INNER WEST

DEVELOPMENT ASSESSMENT REPORT

Application No.	DA/2021/0841
Address	115 Short Street BIRCHGROVE NSW 2041
Proposal	Demolition of existing dwelling and construction of a new multi level dwelling, carport to rear and associated works, including tree removal
Date of Lodgement	13 September 2021
Applicant	Whiting Architects
Owner	Ms Belinda J Ainsworth
Number of Submissions	Initial: 3
Value of works	\$1,300,000.00
Reason for determination at Planning Panel	Clause 4.6 variation exceeds 10%
Main Issues	<ul style="list-style-type: none"> • Variation to Landscaped Area, Site Coverage and Floor Space Ratio development standards • Adverse streetscape and heritage impacts • Unsatisfactory response to desired future character controls • Unsatisfactory on-site amenity outcomes • Adverse amenity impacts to adjoining properties • Inadequate tree planting • Site suitability
Recommendation	Refusal
Attachment A	Plans of proposed development
Attachment B	Clause 4.6 Exception to Development Standards

1 EXISTING FLOOR PLAN
A002 SCALE 1:100 @ A3

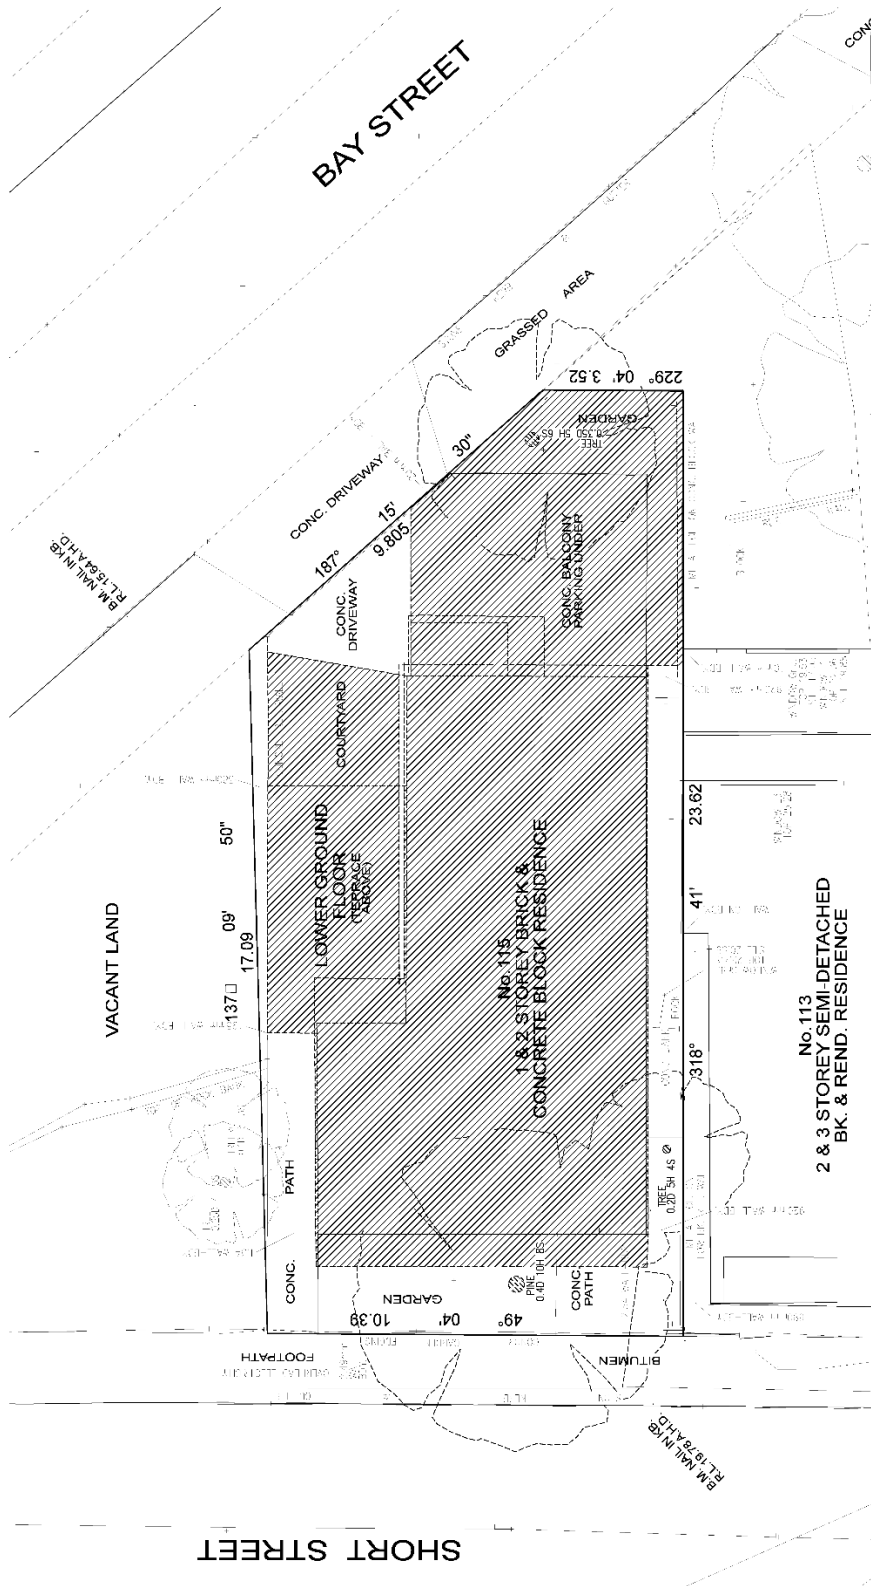
Comment: The “existing floor plan” provided shows the footprint of the existing dwelling. This is generally acceptable from a heritage perspective as the existing dwelling is a contemporary dwelling that has no heritage significance. The west elevation shows the proposed dwelling in the context of the adjoining terraces at 111 and 113 Short Street.

1 PROPOSED WEST/STREETSCAPE ELEVATION
A202 / SCALE 1:100 @ A3

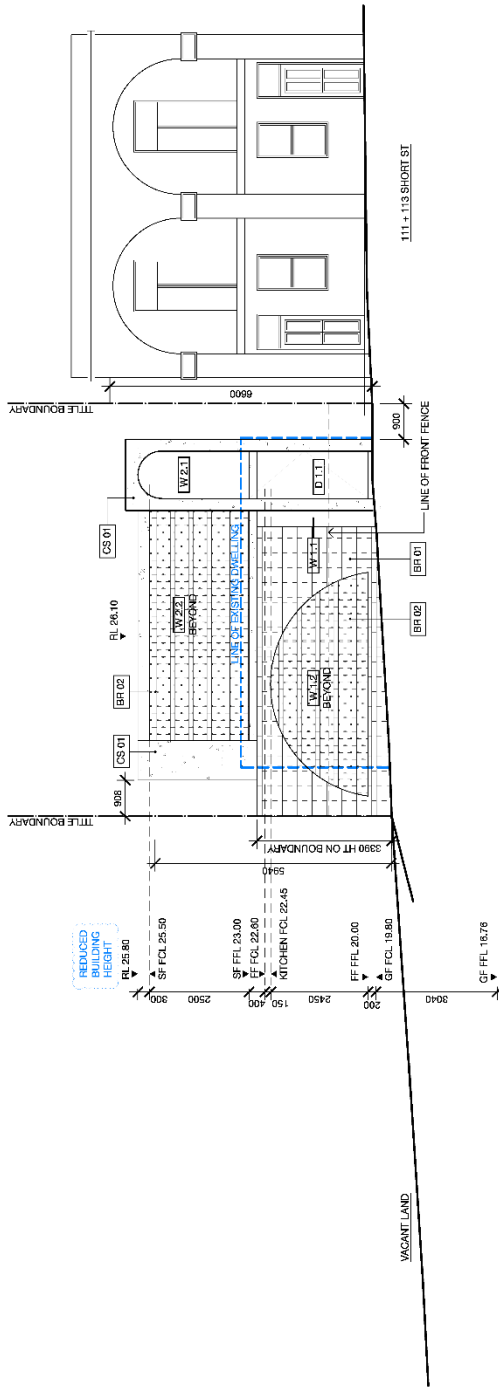
Comment: *The width of the west (streetscape) elevation will present to the street with horizontal detailing, rather than vertical. The width and the detail of the front façade must be amended to respect the characteristic width of dwellings and terraces in the Short Street streetscape.*

1 PRELIMINARY SECTION
A300 / SCALE 1:100 @ A3

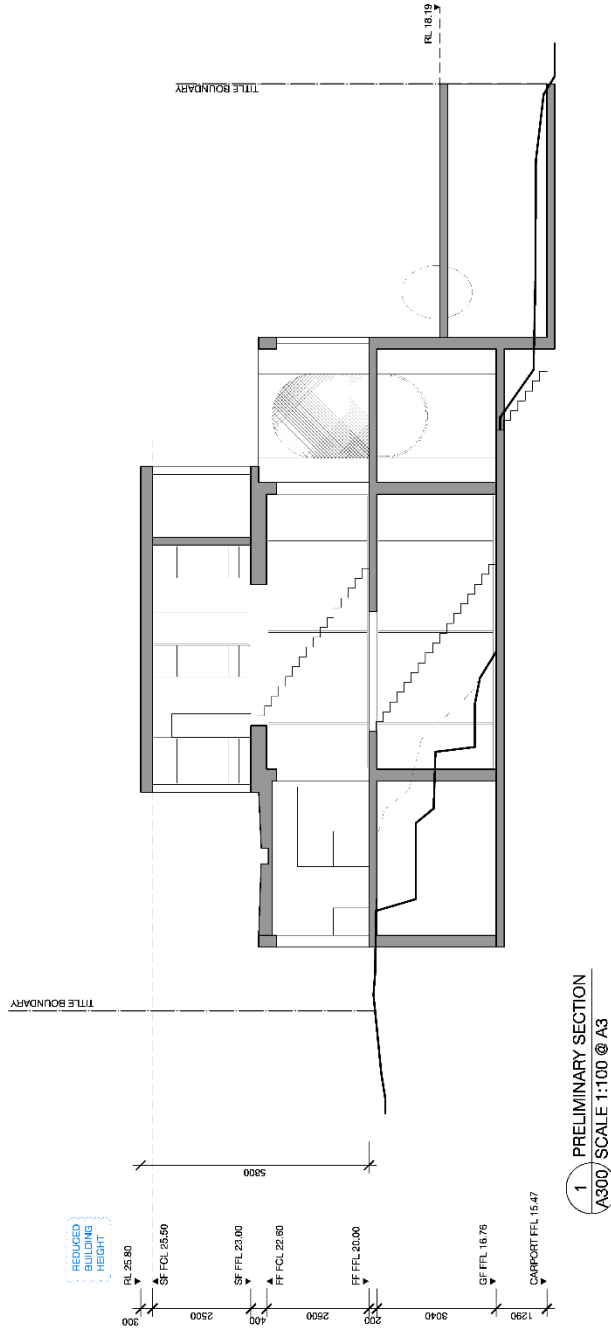
Comment: *The section drawing illustrates a large amount of excavation of sandstone is proposed to enable bedroom 3, approximately one third of the area of the rumpus room, the bathroom and basement storage on the ground level. Bedroom 3, the basement storage and one third of the northern section of the floor area of the rumpus room must be deleted from the ground floor level to retain the sandstone, to ensure the proposal is consistent with C1 a. and b. of Section C1.19 of the DCP.*
